GOVERNMENT OF THE DISTRICT OF COLUMBIA
DISTRICT DEPARTMENT OF TRANSPORTATION

MEMORANDUM

SUBJECT: **BZA Application No. 17281 - Supplemental Review**
Special Exception for a Gasoline Station at 4675 South Capitol Street, SW, Square 6274, Lots 1 and 4, in a C-3-A District

SUBJECT: **BZA Application No. 17281** – Special Exception for a Gasoline Station at 4675 South Capitol Street, SW, Square 6274, Lots 1 and 4, in a C-3-A District

1 / SP-1 SITE PLAN W/ LANDSCAPING

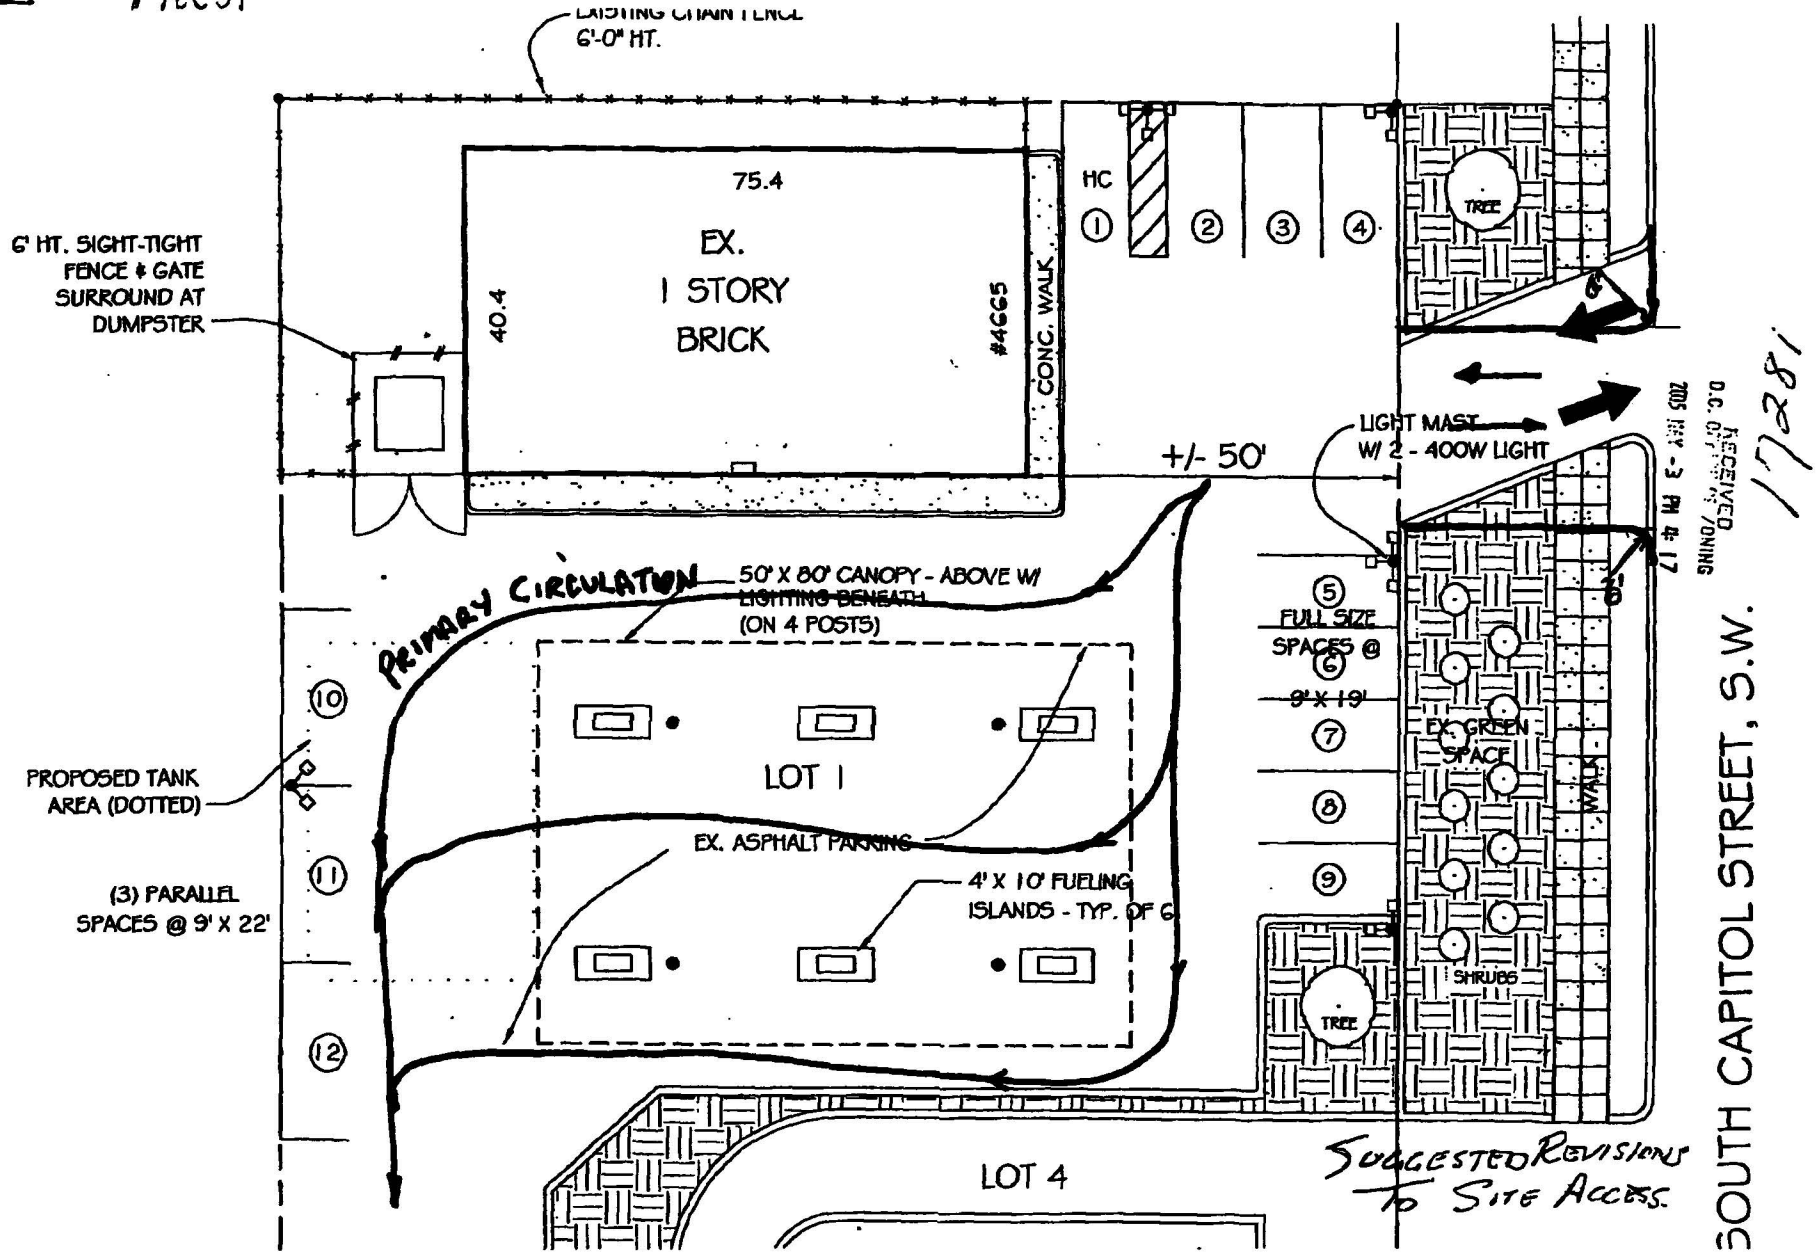
DDOT supports the findings in the traffic analysis; the adjacent street network can accommodate the gasoline service station. However, the consultant recommended several modifications to an adjacent parcel that were agreed upon by the property owner and should be part of the approval conditions, if approved, as the changes will improve overall cite circulation. An existing bank located immediately south of the service station on the same parcel will have access aisles reconfigured to direct traffic to exit to the rear driveway, shared by both uses, to access Southern Avenue, SE. These changes are shown on the revised site plan. (Attachment B)

The applicant has addressed DDOT concerns by retaining a traffic consultant to analyze the traffic conditions and incorporating circulation improvements on revised site plans. Accordingly, DDOT has no objections to the application.
